Service Bulletin

Subject: Information on Ordering New Delphi Style Fuel Pump

Brand:	Model:	Model Year:		VIN:		Engine:	Transmission:
		from	to	from	to		
Chevrolet	Silverado	2016	2017			5.3L Engine (RPOs L83, L8B)	8 Speed Transmission (RPOs M5U, M5X)
GMC	Sierra

Stanadyne style fuel pump part number 12669519 and fuel pipe part number 12673077 as shown above.

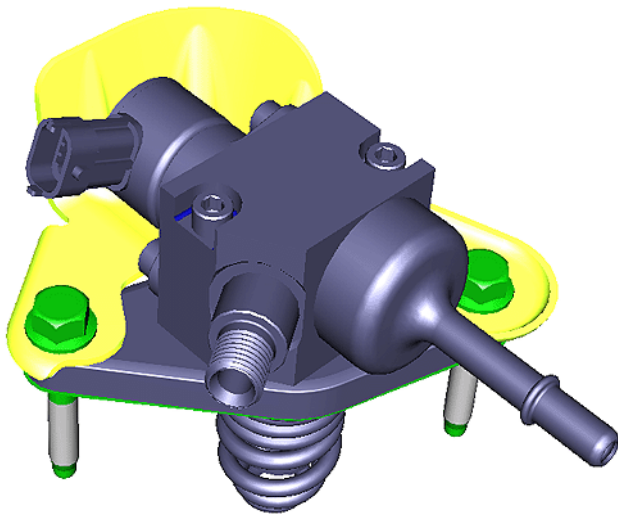
The purpose of this Bulletin is to inform dealership personnel that when replacing the fuel pump, the vehicle should be serviced with the same style high pressure fuel pipe and SIDI fuel pump it was equipped with for the following reasons:

- DTC P00C6 may set during cold starts.
- DTCs P228C and P228D may be set during other extreme hot or cold driving.
